RAI 3.6.2.2.2-1a (High Voltage Insulators)

LRA 3.6.2.2.2 Degradation of Insulator Quality due to Presence of Any Salt Deposits and Surface Contamination, and Loss of Material due to Mechanical Wear

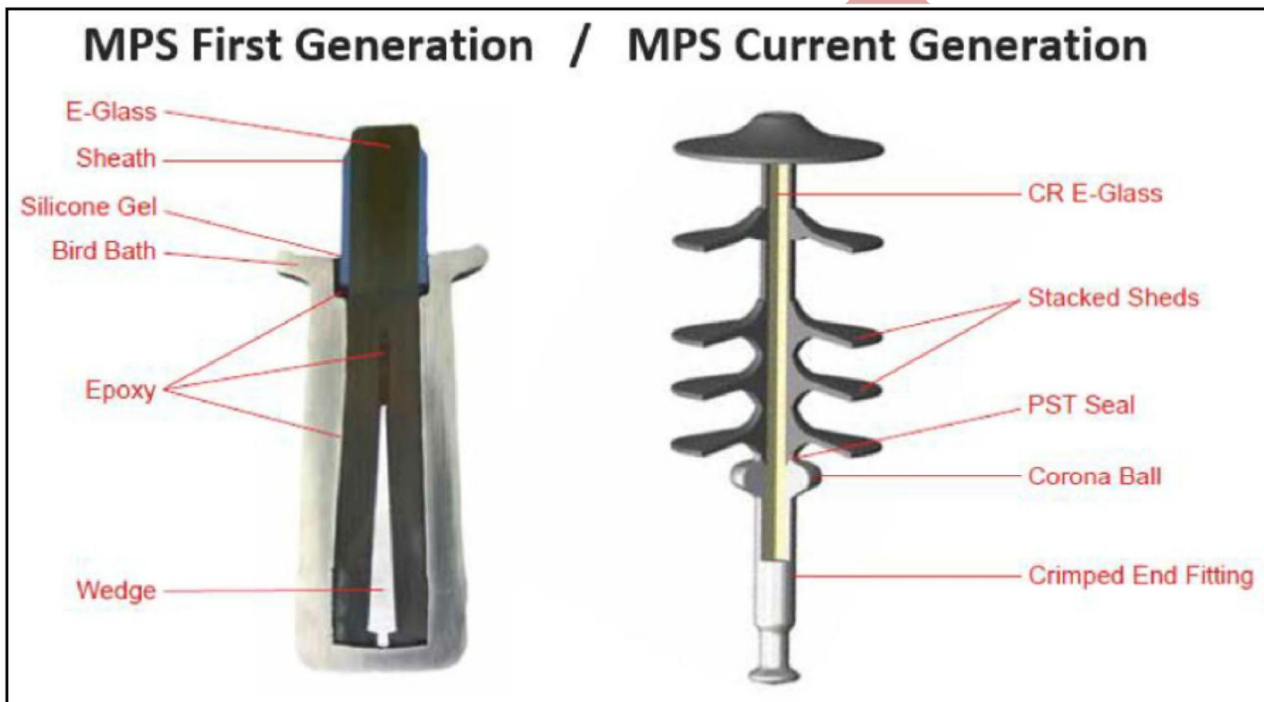
1. The material listed in the applicant's response to RAI 3.6.2.2.2-1 seems to have omitted certain material that are used in construction of the polymer insulators. According to vendor and EPRI literature, these include: epoxy, silicone gel, sealants, and ductile iron.

1. Explain why epoxy, silicone gel, sealants, and ductile iron are not listed in the response to RAI 3.6.2.2.2-1 as materials that are used in construction of polymer high-voltage insulators.

Information from the manufacturer (MacLean Power Systems or MPS) of the RBS polymer insulators does not discuss "ductile iron" for the corona ring or the end fittings, which are the only metal components on the insulators. The connection hardware does include ductile iron.

The response to RAI 3.6.2.2-1 stated, “The RBS polymer high-voltage insulators and connection hardware have the following materials: fiberglass, silicone rubber, aluminum and aluminum alloy, steel and steel alloys, galvanized metal (galvanized ductile iron, galvanized forged steel, steel hot dip galvanized).” Therefore, galvanized ductile iron is explicitly identified.

The RBS polymer high-voltage insulators are a recent generation of MPS polymer insulators that have been manufactured since 2007. The RBS polymer insulators do not use epoxy. The following figure shows the difference between the first generation of MPS polymer insulators and the generation of MPS polymer insulators that are used at RBS.

The MPS polymer insulators in service at RBS use a PST sealing system, which is a triple seal design. The triple seal or PST seal comprises the primary seal (P), the secondary seal (S), and the tertiary seal (T). The primary seal is a silicone rubber sheath compressed into the chamfer of the crimped end fitting. The secondary seal is RTV (room temperature vulcanizing) silicone applied to the rod, sheath, and end fitting interface. The tertiary seal is a final external RTV silicone seal applied to the sheath and end fitting interface. The RBS polymer insulators do not utilize silicone gel. The response to RAI 3.6.2.2-1 included silicone rubber, but did not explicitly identify RTV silicone as a type of silicone rubber. The silicone rubber material includes the RTV silicone that is part of the PST seal system. The RBS polymer insulators do not include silicone gel or sealants other than RTV silicone.
